Re: Petition for Zoning Re-Classification
 Item #3
 Rosemeier Property, Belair Road at Beltway

**Notice of Public Hearing
 Petition for Re-Classification**

BALTIMORE COUNTY ZONING PLANS ADVISORY COMMITTEE

ROSEMEIER PROPERTY 7720 BELAIR ROAD

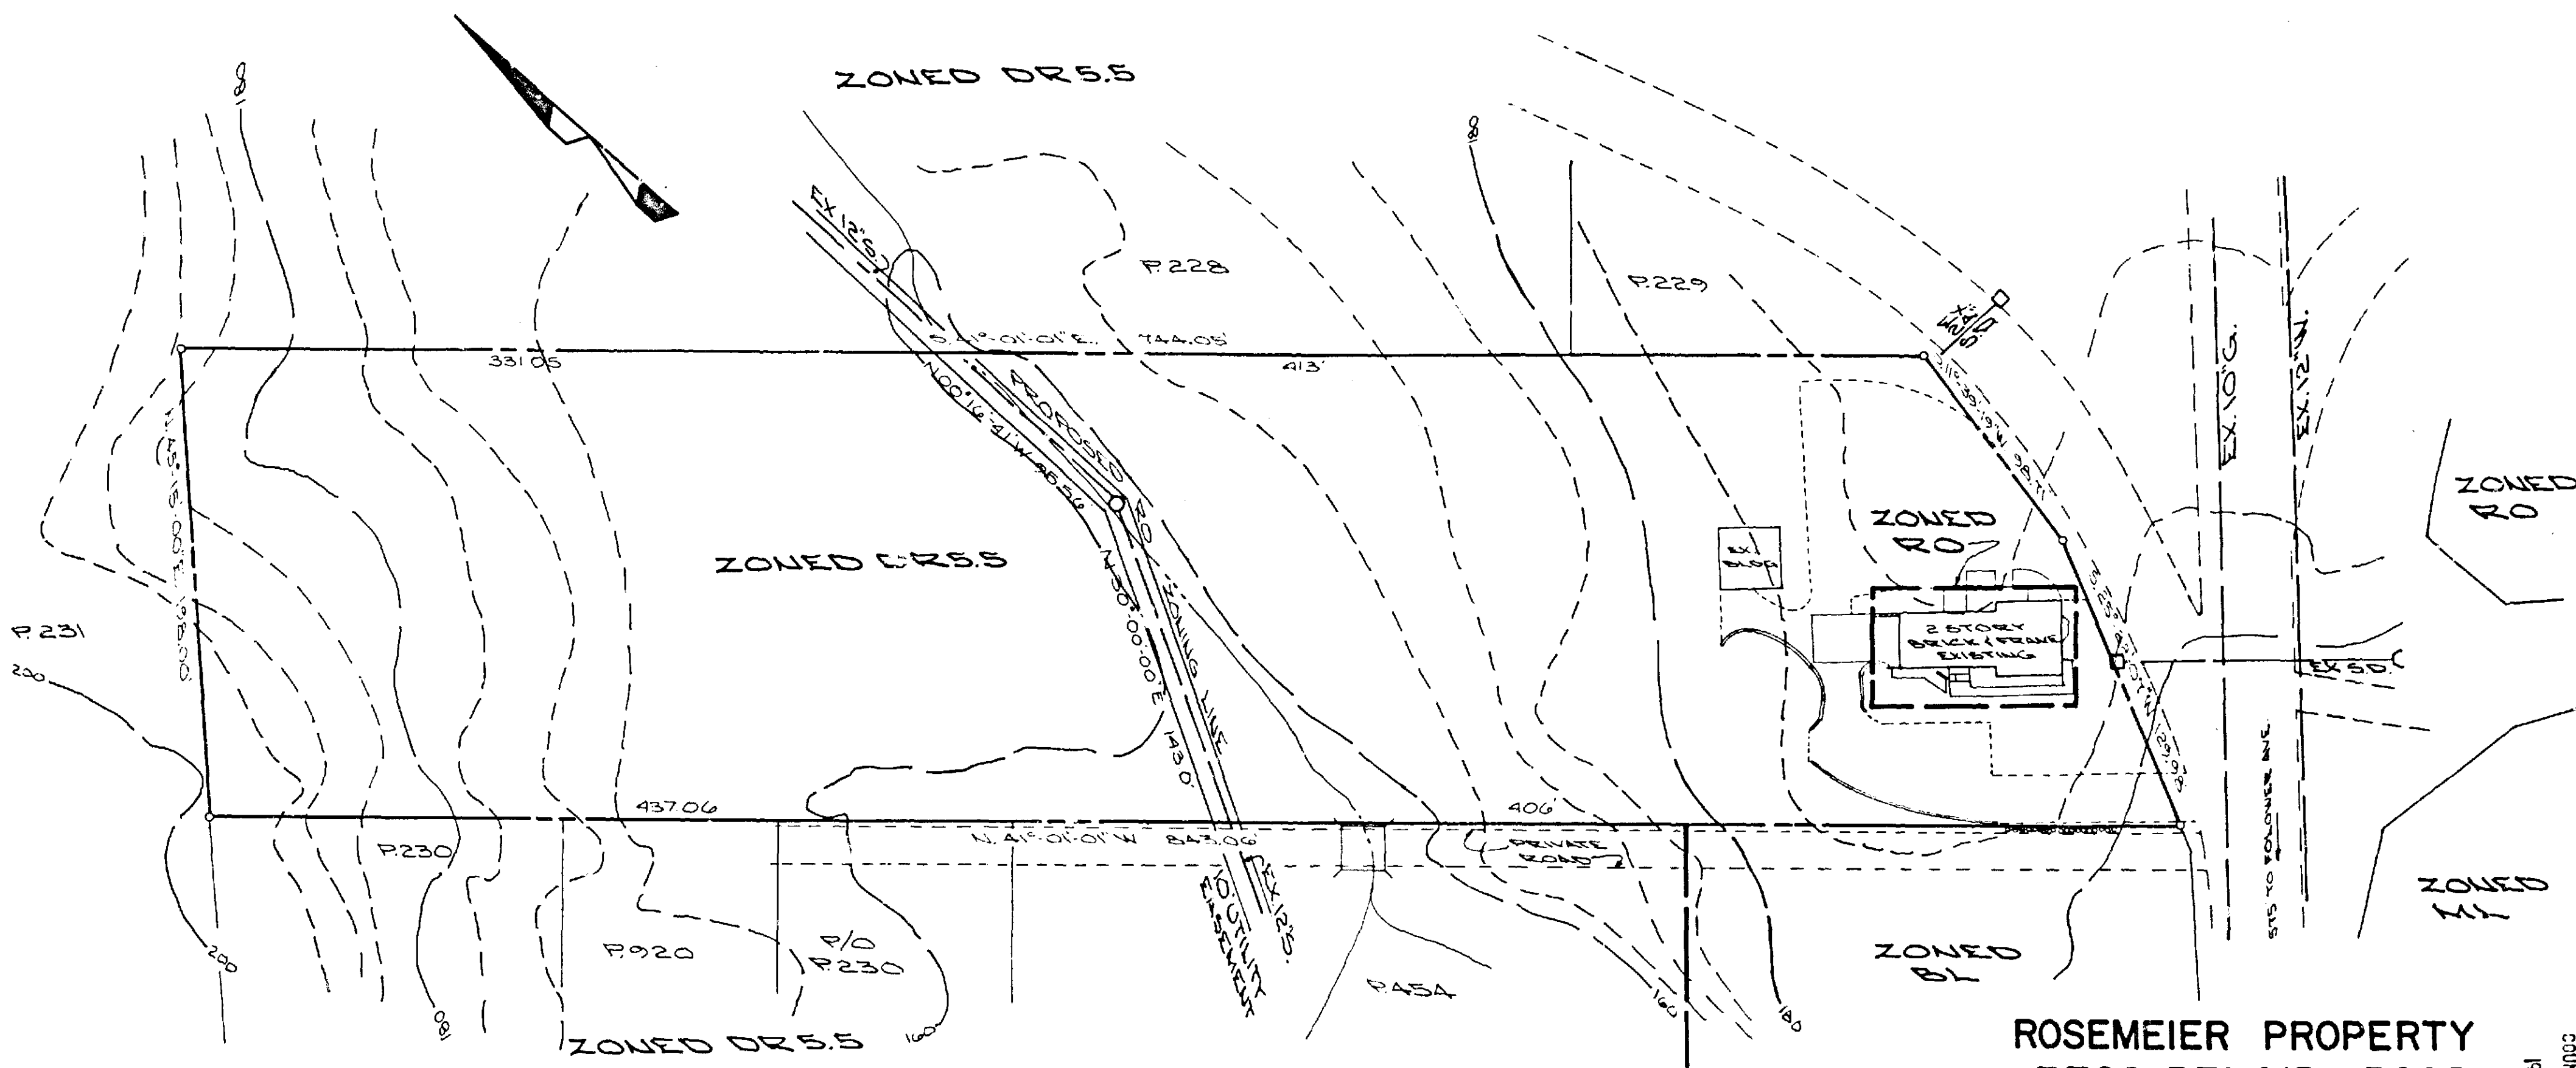
As part of our continuing coordinated planning process, we have received for review a rezoning plat of the Rosemeier property, 7720 Belair Road, as located along the west side of U.S. Route 1 at the southbound exit ramp from the Baltimore Beltway (Interstate Route 695). Our review of the submitted plat has revealed a number of access related issues along U.S. Route 1 from the Beltway southerly to Fowler Avenue that seem to warrant comprehensive planning revisions to correct a number of deficiencies which could constitute significant future problems.

At the U.S. Route 1 interchange, the eastbound to southbound outer connection joins Belair Road immediately adjacent to the entrance to the Rosemeier property. Abutting this entrance is another entrance to the Lodge Cliff restaurant/catering facility which is contiguous to Double Rock Park. Motorists entering Belair Road from the ramp are controlled by a yield sign. However, the absence of a transitional speed change lane causes numerous conflicts. Compounding this problem is the availability
